Access Compliance Report

Public Rights-of-Way

Intersection ID: 29142	Main Street: APPLEDALE_DR	Cross Street: BRIDGEVILLE_LN	Location: W
ADA ID: 58ACDA2B4836	Ramp Type: PerpDiag	Initial Pass/Fail: Fail	Overall Compliance: No
Severity Score: 22.5			
Codes/Mitigation Info/Possible Solution		Field Measurements/Component Compliance

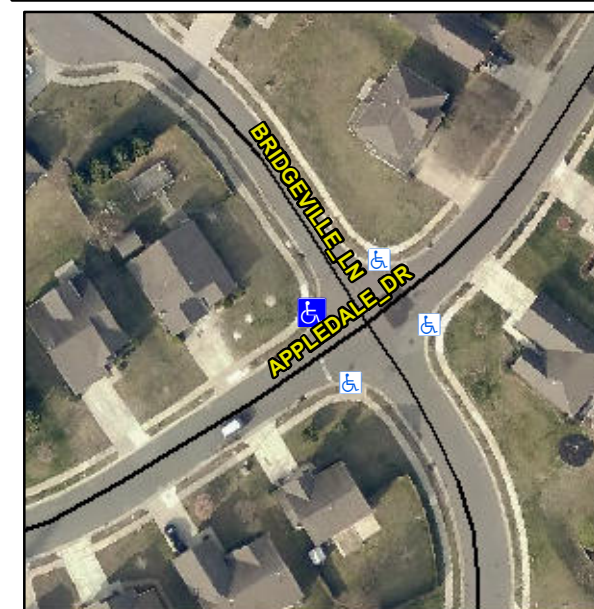
Not Found, R304.5.1, R304.2.2, R304.5.3

Compliance	Description	Data	Compliance	Description	Data
N/A	Ramp Length (in)	47.5	No	Ramp Slope (%)	9.4
No	Ramp Width (in)	47.0	No	Ramp XSlope (%)	3.0
N/A	Flare Type LT	N/A	N/A	Flare Type RT	N/A
N/A	Flare Slope LT (%)	N/A	N/A	Flare Slope RT (%)	N/A
N/A	Flare Traversable LT?	N/A	N/A	Flare Traversable RT?	N/A
N/A	Landing Length (in)	N/A	N/A	DWS Provided?	N/A
N/A	Landing Width (in)	N/A	N/A	DWS Contrast?	N/A
N/A	Landing Slope (%)	N/A	N/A	DWS Length (in)	N/A
N/A	Landing X Slope (%)	N/A	N/A	DWS Full Width?	N/A
N/A	Landing Curb? (Y/N)	N/A	N/A	DWS Offset (in)	N/A
N/A	Shared Landing?	N/A			
N/A	Gutter Ponding?	N/A	N/A	Gutter Slope (%)	N/A
N/A	Gutter Lip Ht (in)	N/A	N/A	Gutter X Slope (%)	N/A
N/A	Painted X Walk1?	No	N/A	Painted X Walk2?	No
	X Walk 1 Direction	To S		X Walk 2 Direction	To E
N/A	X Walk 1 Width (in)	N/A	N/A	X Walk 2 Width (in)	N/A
	X Walk 1 Slope (%)	4.0		X Walk 2 Slope (%)	2.7
	X Walk 1 X Slope (%)	4.1		X Walk 2 X Slope (%)	2.5

Remove & Replace Curb Ramp With Two New Directional Ramps or Equivalent.
